PROPOSED TECHNICAL SPECIFICATION (TS) CHANGE

SEQUOYAH NUCLEAR PLANT UNITS 1 AND 2

DEPARTURE FROM NUCLEATE BOILING RATIO (DNBR) LIMITS BASES CHANGE

- 1) NUCLEAR PLANT(S): Sequoyah Units 1 and 2
- 2) SUBJECT (TITLE): Increased F Delta H from 1.55 to 1.62, Increased FQ From 2.32 to 2.4, With Mini RTDP
- 3) The written safety evaluation of the revised procedure, design change or modification required by 10CFR50.59(b) has been prepared to the extent required and is attached. If a safety evaluation is not required or is incomplete for any reason, explain on Page 2.

SEQUOYAH FINAL SAFETY ANALYSIS REPORT UNITS 1 and 2
Rod Cluster Control Assembly Ejection Fuel and Clad Temperature vs. Time (EOL, HFP)
Figure 15.4.6-2

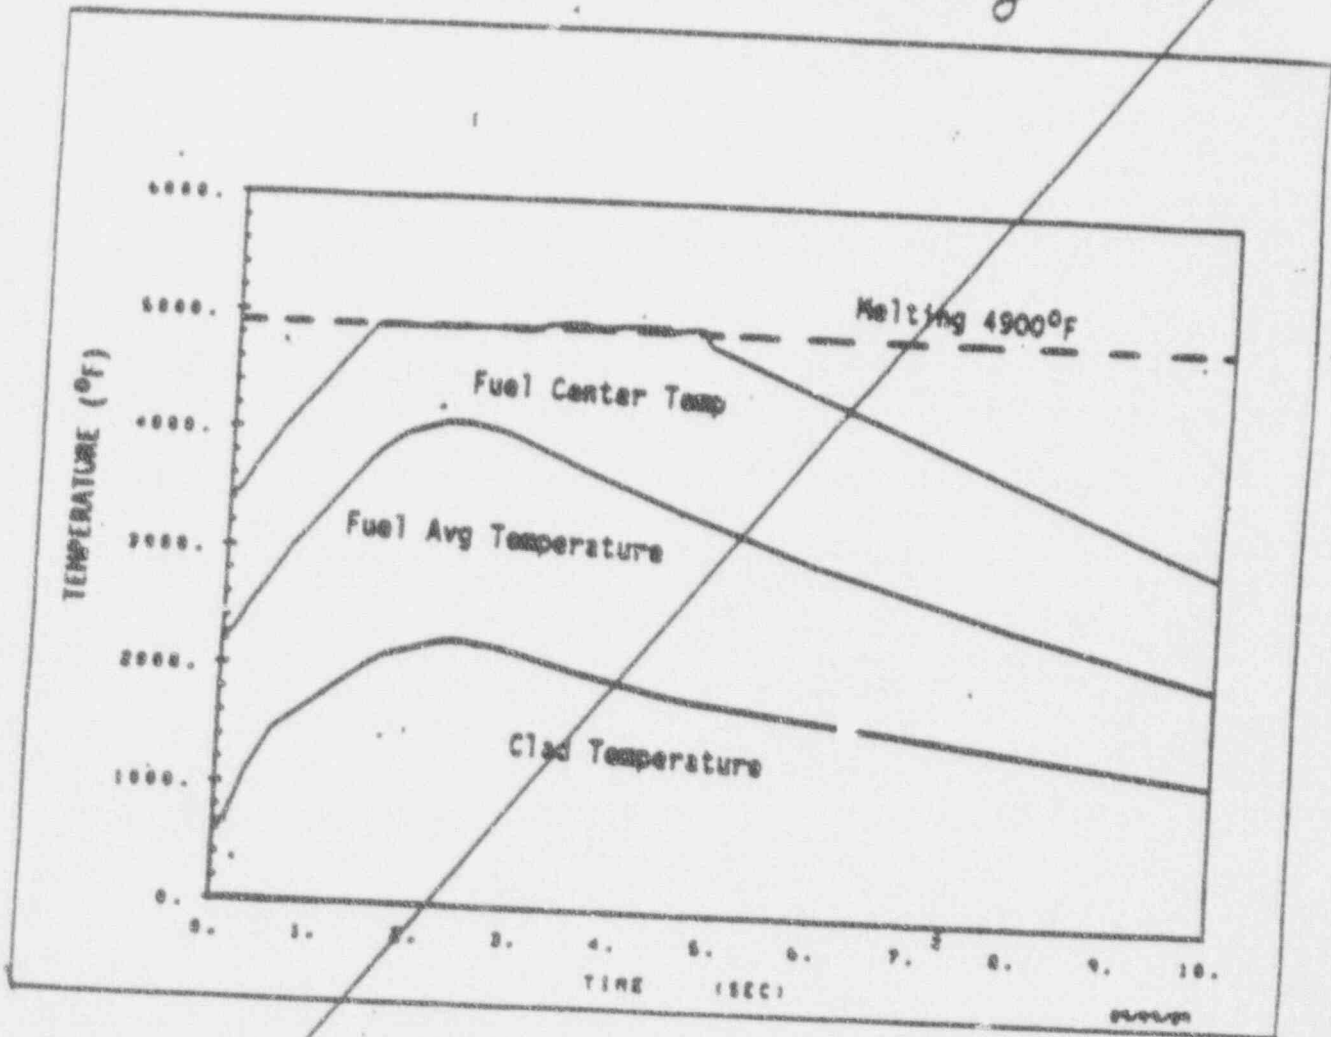
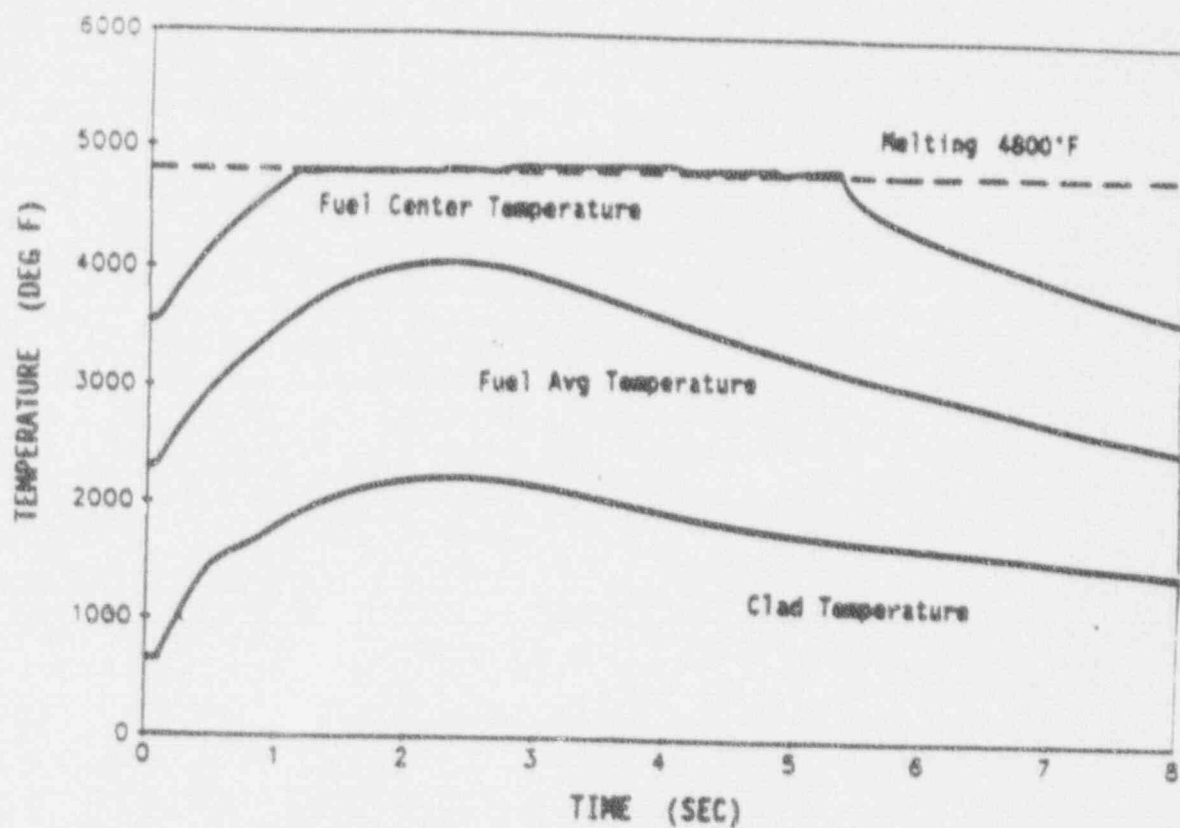
9.1.5 For the RCCA Ejection event the following changes were made: Text changes, References 25 and 29 updated, Tables 15.4.1-12 (sheet 3) and 15.4.6-1 were revised, and Figures 15.4.6-1 through 15.4.6-2 were replaced.

Replace with the following
